# Product Safety Recall

## N202316700 Starter Ground Cable Breakage – US Only

| <b>Condition</b>  | Isuzu Motors Limited has decided that a defect, which relates to motor vehicle safety, exists in certain 2018-2021 model year Chevrolet 6500XD Low Cab Forward vehicles produced before August 14, 2020. In the affected vehicles, the ground cable connecting the starter motor to the vehicle frame may break at the starter-side eyelet, which can result in an engine no-crank or slow-crank condition, causing the vehicle not to start. If the driver attempts to start the engine after the cable has broken, electrical current will flow through the steel braiding of the power steering hose rather than through the broken cable, generating heat within the power steering hose. Once the cable is broken, if the driver makes repeated efforts to restart the engine or if the key is held in the engine start position for an extended period of time, enough heat may be generated to melt and potentially to rupture the power steering hose. If the power steering hose ruptures, power steering fluid may leak onto a hot engine or exhaust surface increasing the risk of a fire. |

5652008

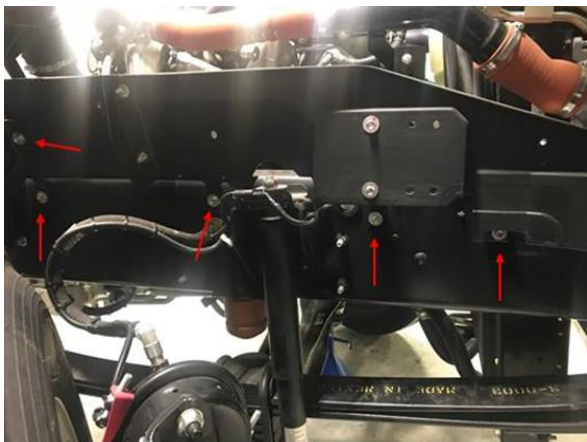
9. Paint the bolt heads with high visibility paint marker after proper torque has been completed.
10. If the ground harness broke upon removal or was found broken, continue to the Power Steering Hose Replacement section in this bulletin to complete the campaign. If the ground harness was not broken, proceed to Step 11.

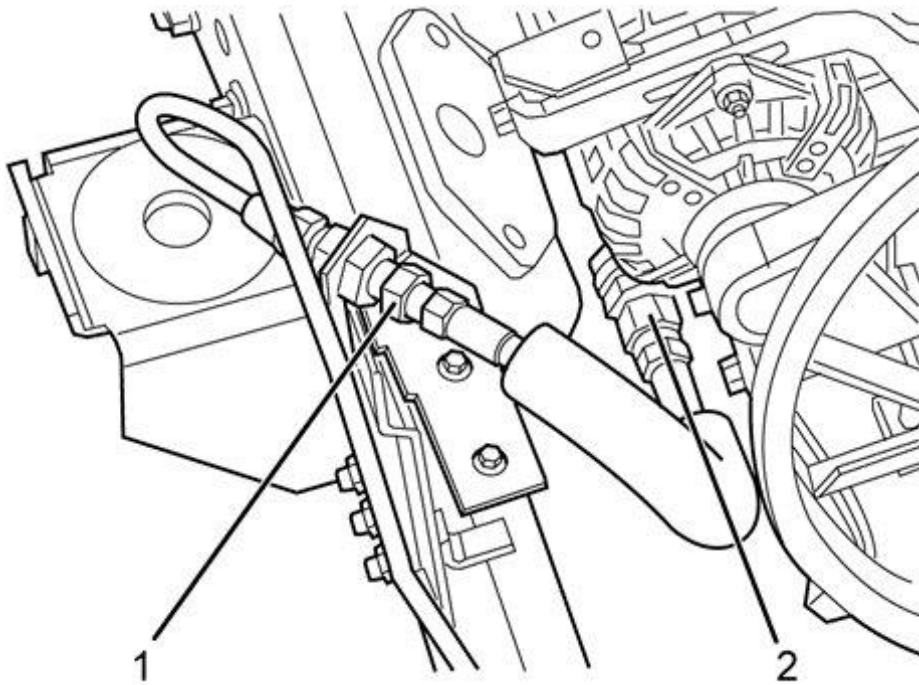
13. Remove the right-side noise cover from the frame by removing the five (5) bolts. Set the bolts aside for reuse later.
14. Place a drain pan under the power steering hose frame union fitting.
